PROJECT REFERENCE NO.	R-5021	SHEET NO.	UC-5
DESIGNED BY:	10/29/2021		
DRAWN BY:			
CHECKED BY:			
APPROVED BY:			
REVISED:			
NORTH CAROLINA DEPARTMENT OF TRANSPORTATION UTILITIES ENGINEERING SEC. PHONE: (919) 707-6690 FAX: (919) 250-4151		UTILITY CONSTRUCTION PLANS ONLY

### UTILITY CONSTRUCTION

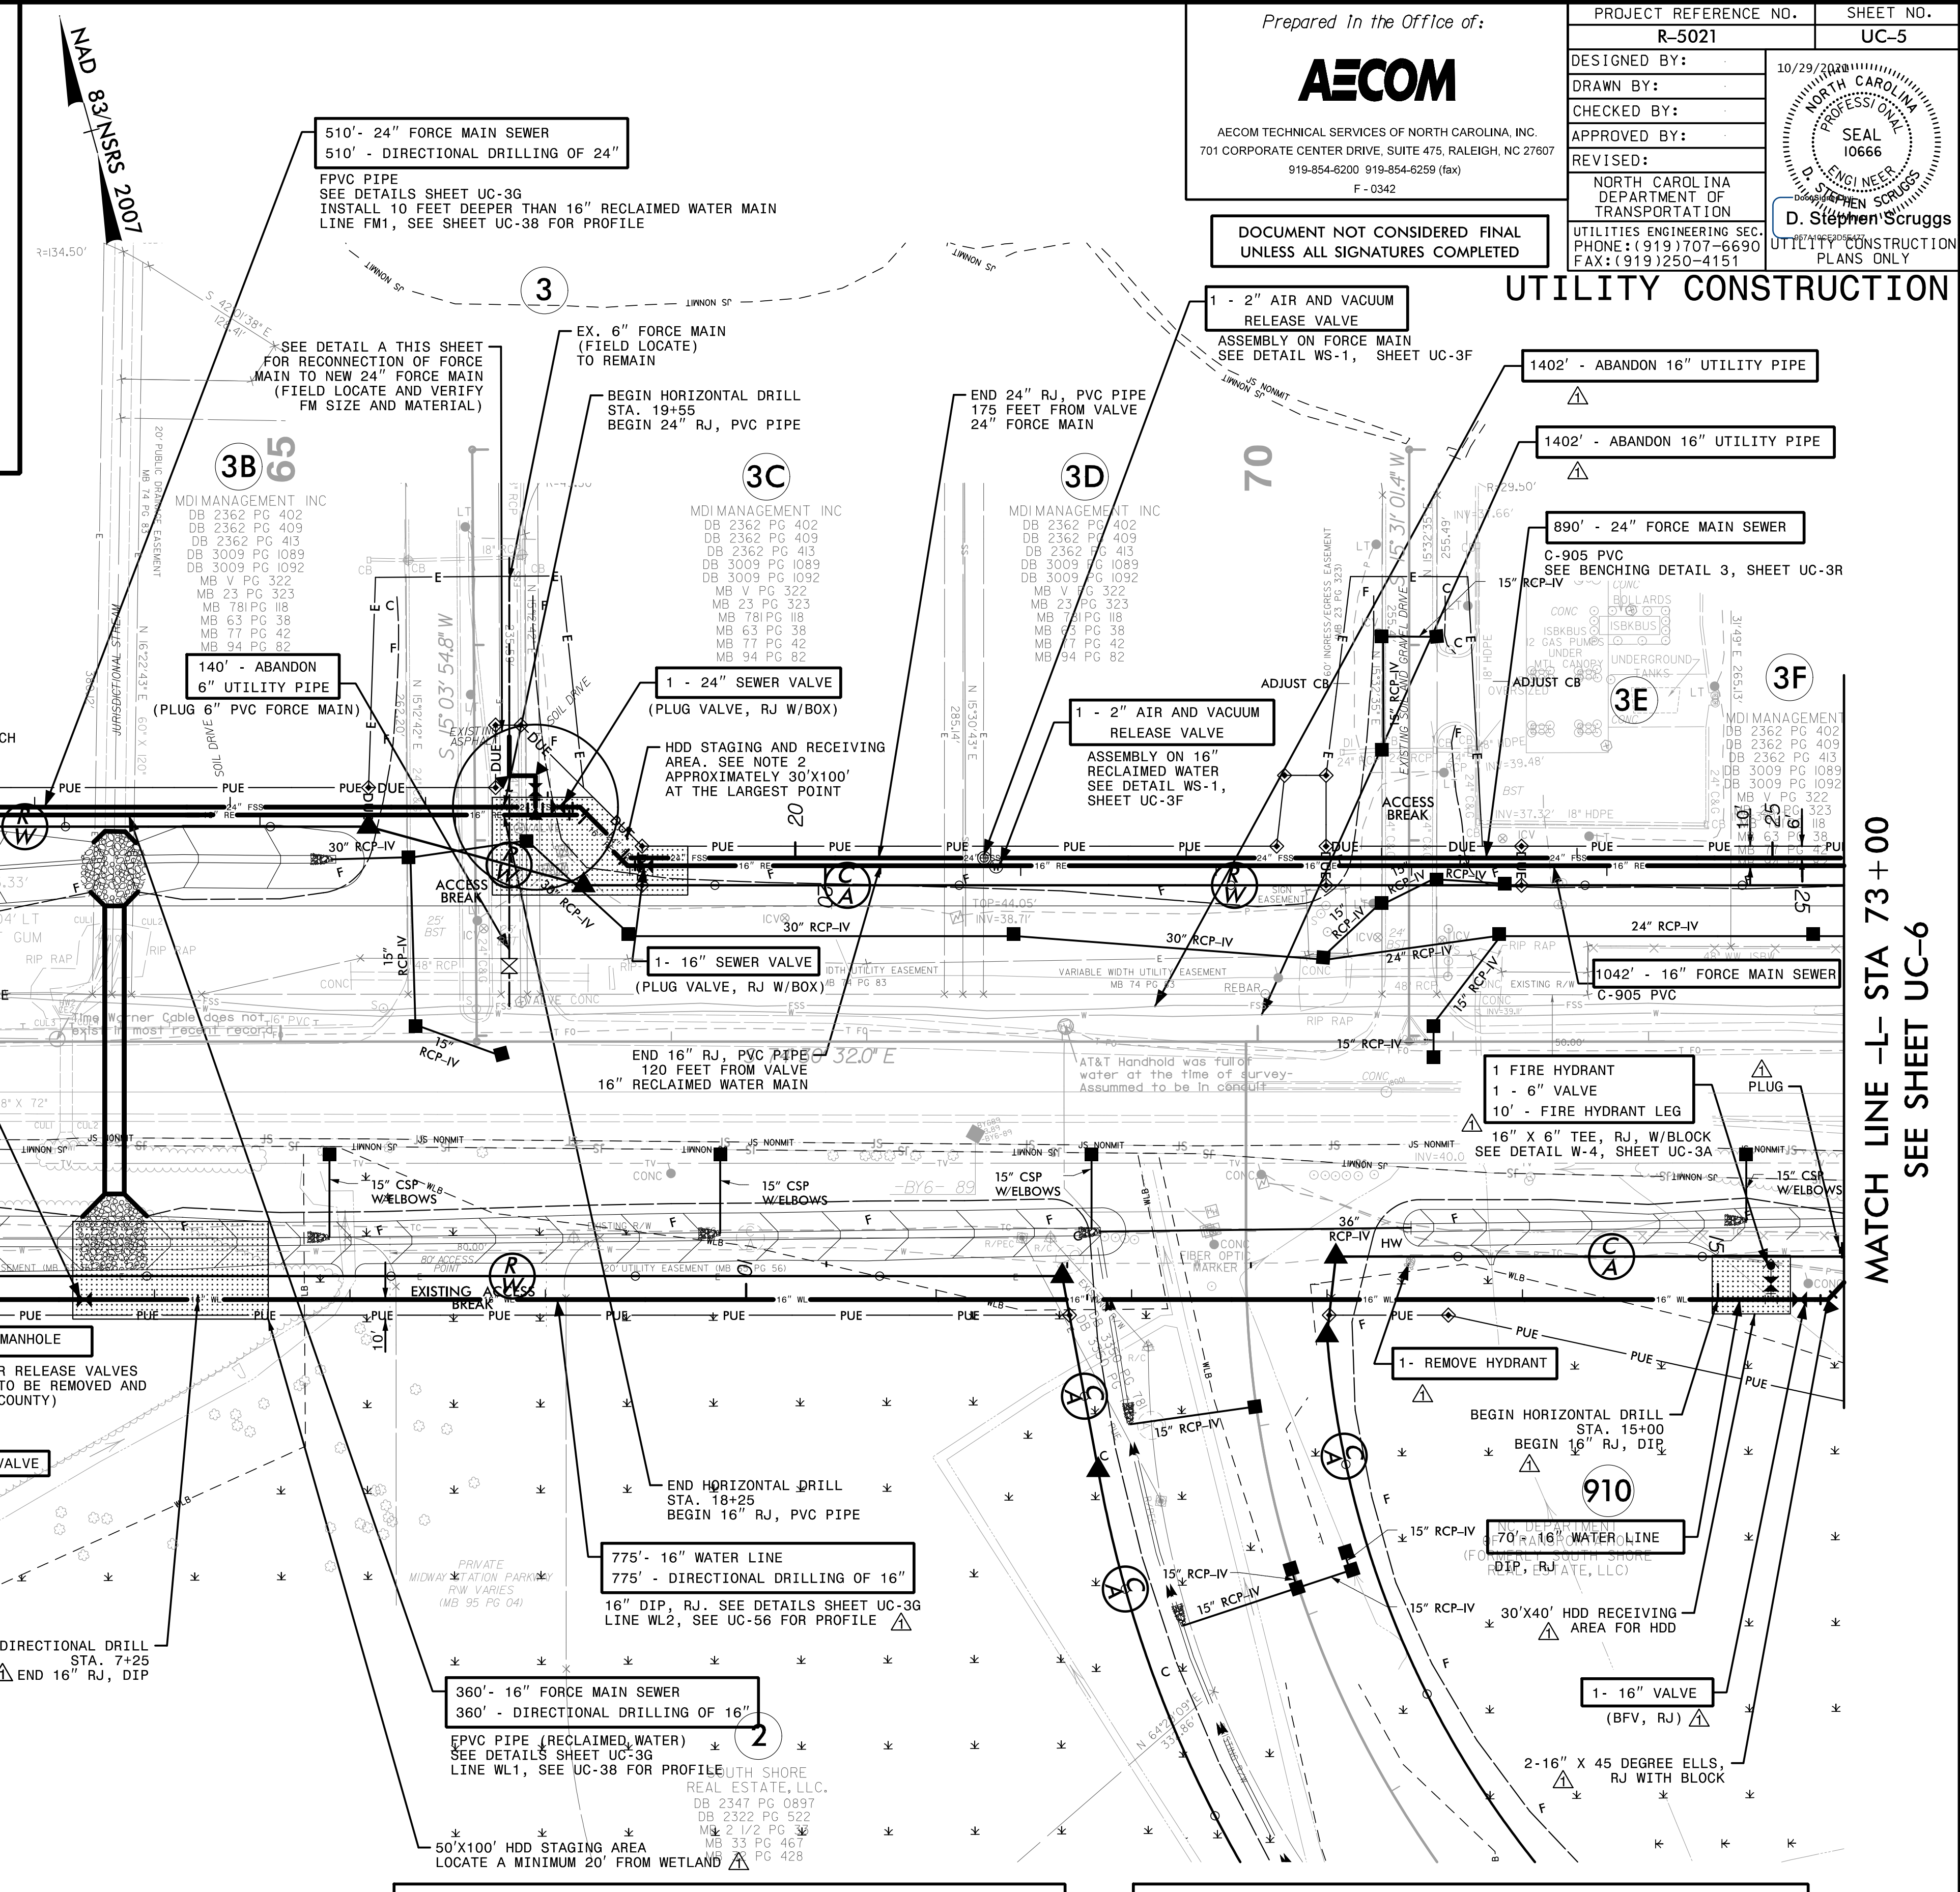
⚠ 16" WATER MAIN RELOCATED AND EXTENDED PER ADDENDUM NO. 1.  
REMOVED NOTE BELOW PAY ITEM FOR ABANDON UTILITY PIPE PER ADDENDUM NO. 1
